INDESIT company

Model type:
WT5IT

Commercial code:
F026454

Notices

FIG. 1

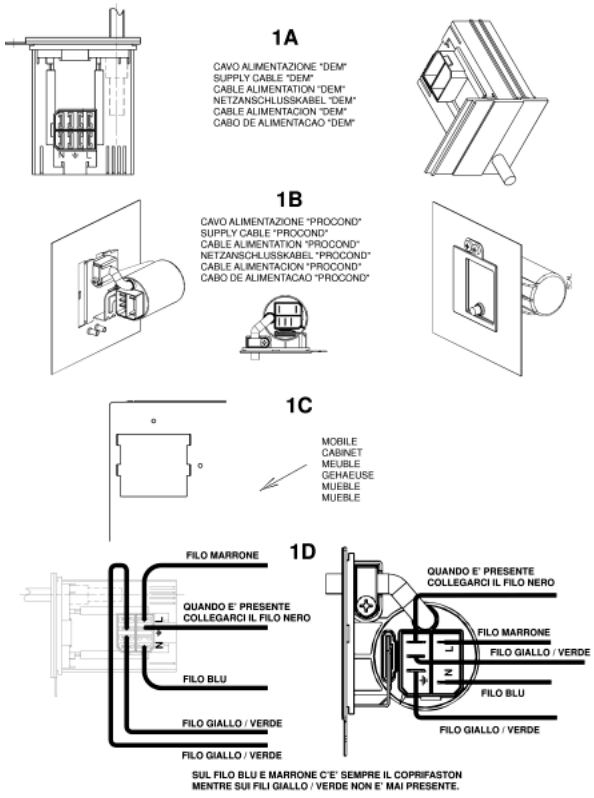
To use premodified wirings on modified products perform the connection to the terminal block of the new cable as shown in fig. 1 - 1D.
The wiring diagrams indicated in the Documentation remain the same.

N1040309FIG1

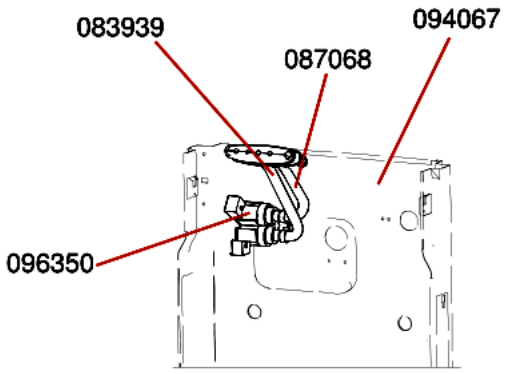
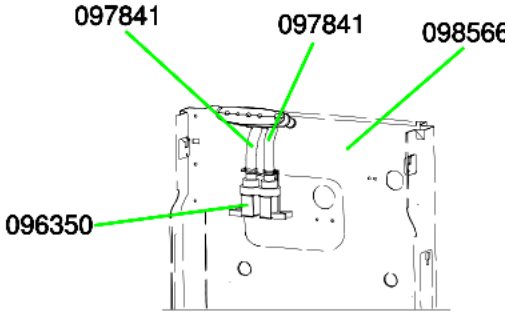
From serial no. 30912.0001, the system used for fixing the loading solenoid valve (spare part code 096350) to the rear panel has been modified on Top Loading washing machines, rotating its position by 90°.
The solenoid valve (spare part code 096350) has been modified with the 45° rotation of a coil; the Replacements Warehouse will continue to manage this part with the same code. When replacing on premodification machines, fit the coils as shown in figure N1040309FIG3-1 and on modified machines, as shown in figure N1040309FIG3-2; to rotate the coil, lift it using a screwdriver and then refit according to the inserts on the plastic.

Replacement codes of the parts affected by this modification (see figure N1040309FIG1):

FIG1 A - PREMODIFICATION STRUCTURE
solenoid valve tube/distributor assembly: premodification 083939;
solenoid valve tube/distributor assembly: premodification 087068;
rear panel: premodification 094067.
FIG1 B - NEW STRUCTURE
solenoid valve tube/distributor assembly: new 097841;
solenoid valve tube/distributor assembly: new 097841;
rear panel: new 098566.

Premodification panels will be managed by the Replacements Warehouse while stocks last; when replacing with new ones on premodification appliances the new tubes must also also be used.
When using the new panels on appliances before serial no. 30609.0001, fitted with solenoid valve code 083940, rotate the coil 45° and follow the instructions given above for code 096350, paying attention during the wiring phase to keep the cables away from the bowl support spring.

N1040309FIG2

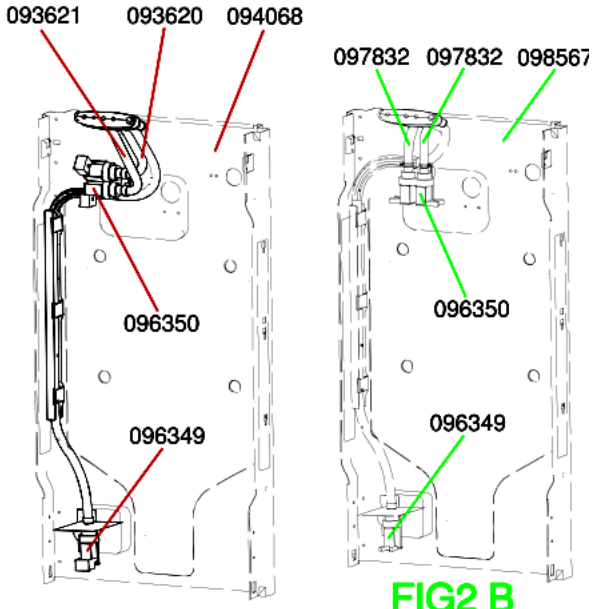
Replacement codes of the parts affected by the modification to WMTL80UK (see figure N1040309FIG2):

FIG2 A - PREMODIFICATION STRUCTURE
solenoid valve tube/distributor assembly: premodification 093620;
solenoid valve tube/distributor assembly: premodification 093621;
rear panel: premodification 094068.
FIG2 B - NEW STRUCTURE
solenoid valve tube/distributor assembly: new 097832;
solenoid valve tube/distributor assembly: new 097832;
rear panel: new 098567.

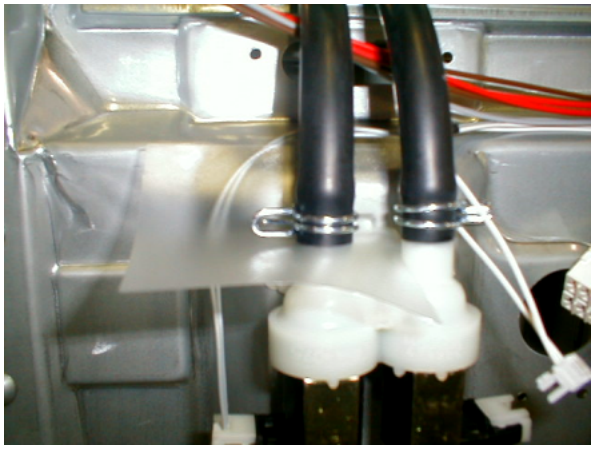
have been equipped with a plastic protection Service code 109798 (shown in N1040321FIG1), to prevent water from damaging the solenoid valve and electronic card.

N1040324FIG1

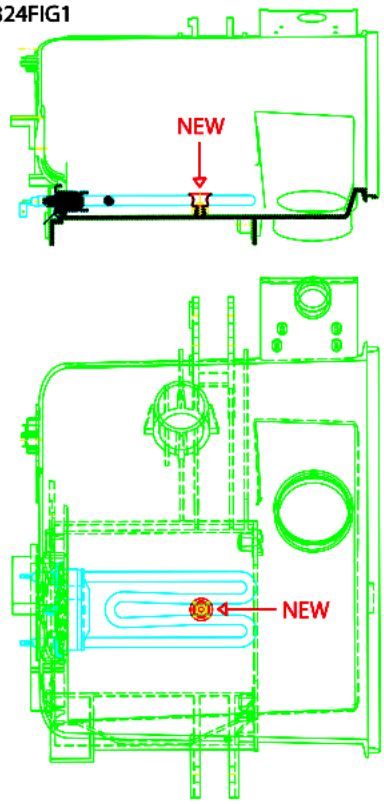
From serial number 40506.0001, the fixing system of the heater to the tank has been modified on all top-load washing machines affected by this note, with the introduction of a metal retainer (image N1040322FIG1 reference NEW) in place of deflector Service code 055322.

The modification has involved both heater and tanks. Given below are the Service codes of the new and old items concerned:

-PLASTIC TANK FOR 600-1000 RPM MACHINES: new 110152, premodification 083805;

-PLASTIC TANK FOR 1200 RPM MACHINES: new 110153, premodification 092023;

-HEATER: new 110148, premodification 083906.

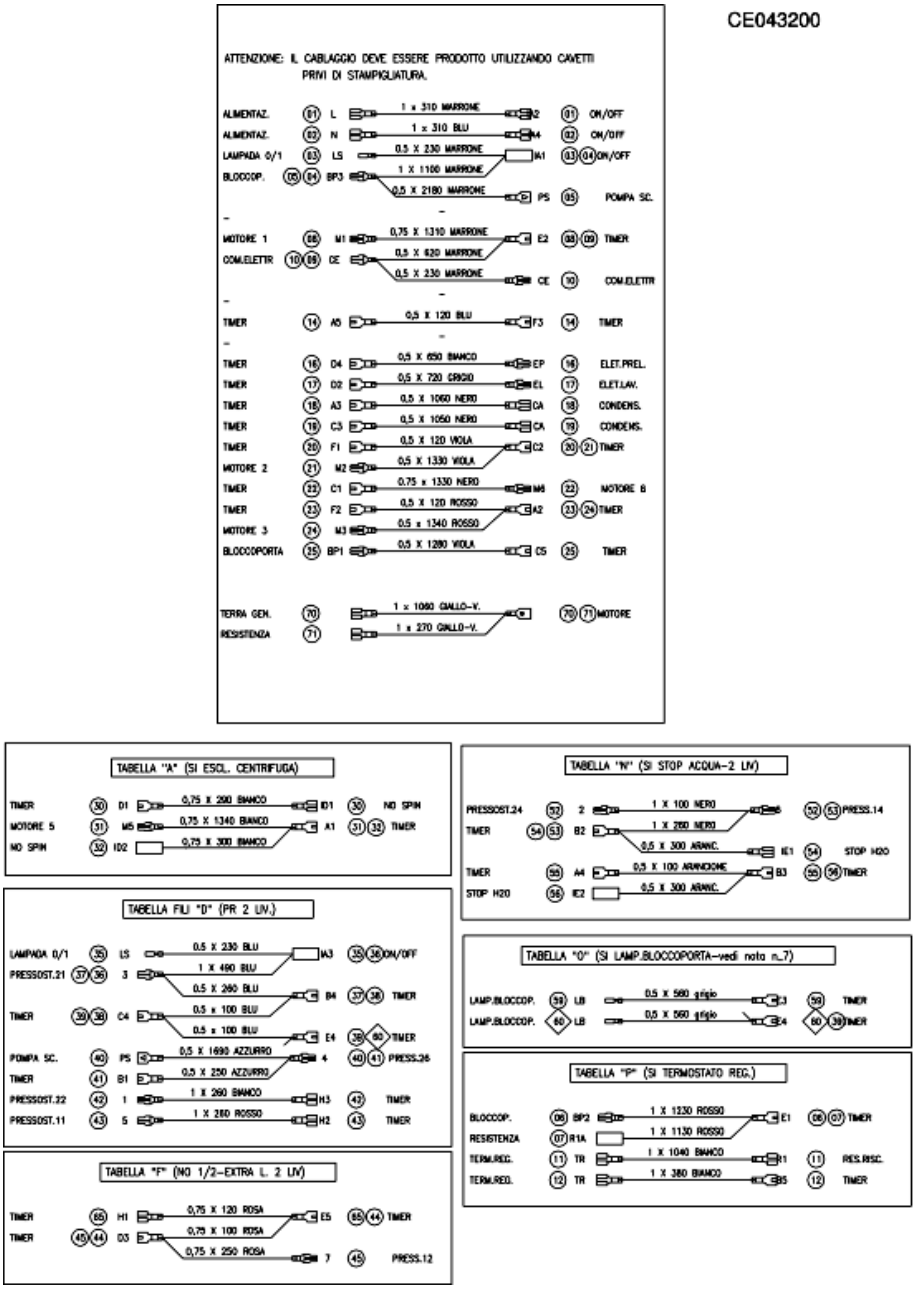
Top Loading washing machines have changed the fix of motor to the tub.
The tub design is changed in the motor fixing side and two new screws code C00268497 are introduced instead of the old screws C00084333 and the old nut:

In assistance on premodification products with the new tubs, you have to fix the motor using the new screws C00268497 instead of the screws and nut that you find in the product.
